**Response to the Approval for the Phase III Investigation Report for
Material Disposal Area C, Solid Waste Management Unit 50-009, at Technical Area 50
Los Alamos National Laboratory, EPA ID No. NM0890010515, HWB-LANL-11-050,
Dated December 8, 2011**

INTRODUCTION

Figure 1 Tier II screening levels for 2-hexanone as a function of depth

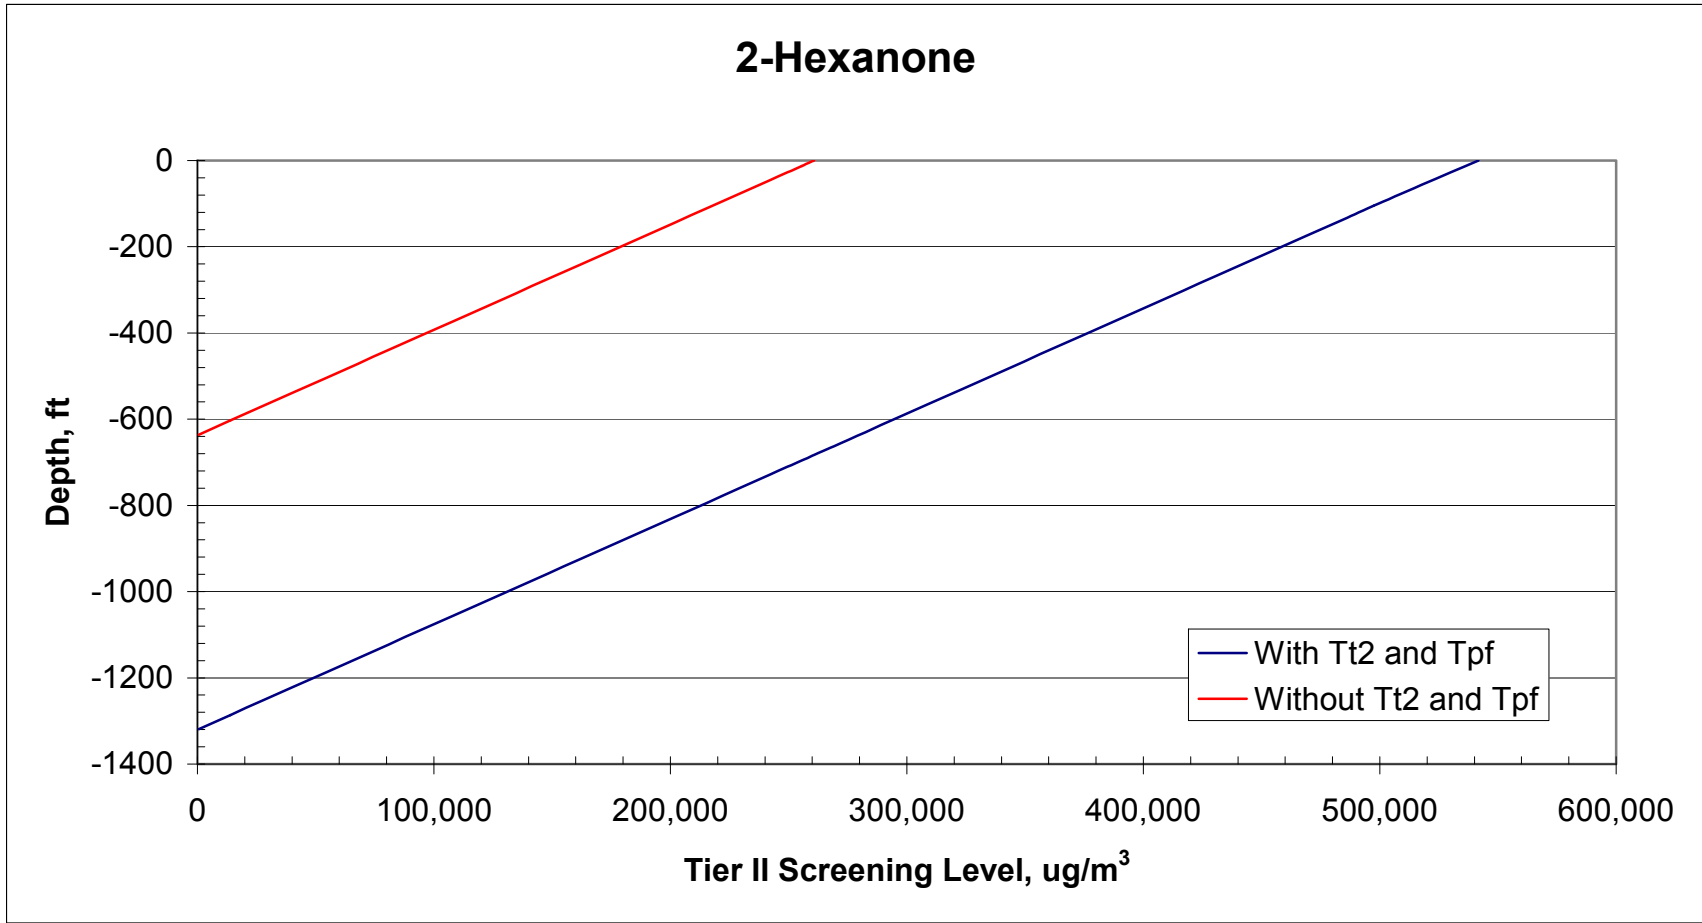
- The Permittees' Tier II analysis is inadequate. The Permittees performed Tier II analysis for specific depths at which the highest concentrations of certain contaminants of interest are currently measured. However, the Permittees neither recognized, nor discussed the fact that Tier II screening levels are depth-dependent. The analysis also only considered diffusion and did not address fracture flow. Both the distance to groundwater and the transport properties of the geologic formations between the contaminant location and the regional aquifer must be considered in order to properly estimate Tier II screening levels.*

For example, the Permittees calculated Tier II screening levels for TCE at the depth of approximately 50 ft bgs. From that location, TCE vapors have to migrate through approximately 550 feet of Bandelier tuff, 300 feet of Tschicoma dacite, and 400 feet of Puye formation before they reach groundwater table. However, these calculations are not applicable to TCE vapors that are already near the top of Tschicoma dacite since they do not have to migrate through a thick sequence of Bandelier tuff before reaching groundwater. Tier II screening levels for TCE at the top of Tschicoma dacite will be much lower than those calculated by the Permittees for the location near the top of Bandelier tuff. The same comments apply to Tier II analysis for tritium. Figures F-3.0-1 and F-4.0-1 give an inaccurate impression that Tier II screening levels for TCE and tritium do not change with depth. The Tier II analysis results are not valid as presented.

The attached Figures 1 through 3 show the depth dependence of Tier II screening levels for 2-hexanone, methylene chloride, and TCE, respectively. The plots labeled "With Tt2 and Tpf" show the screening levels considering attenuation in the dacite and unsaturated Puye Formation. The plots labeled "Without Tt2 and Tpf" do not consider attenuation in the dacite and unsaturated Puye Formation and, therefore, conservatively represent vapor-phase transport through fractures from the top of the dacite to the water table. Similarly, attached Figure 4 shows the screening levels for TCE along with the TCE data presented in Figure F-3.0-1 of the investigation report.

The depth dependence of Tier II screening levels results from concentration gradients associated with diffusive transport (i.e., a greater distance to the water table requires a higher concentration to create the necessary concentration gradient for transport). As explained in Appendix F of the investigation report, the Tier II screening level for tritium was based on pore water transport in the liquid phase rather than vapor diffusion because of the low vapor pressure of tritium (as tritiated water). Because the Tier II screening level for liquid-phase transport considers only advective transport through the unsaturated zone and does not depend on concentration gradients in the unsaturated zone, it would not exhibit depth dependence. Similarly, this Tier II screening level would also be representative of fracture flow since it is based on liquid phase transport. Therefore, additional Tier II screening levels were not evaluated for tritium.
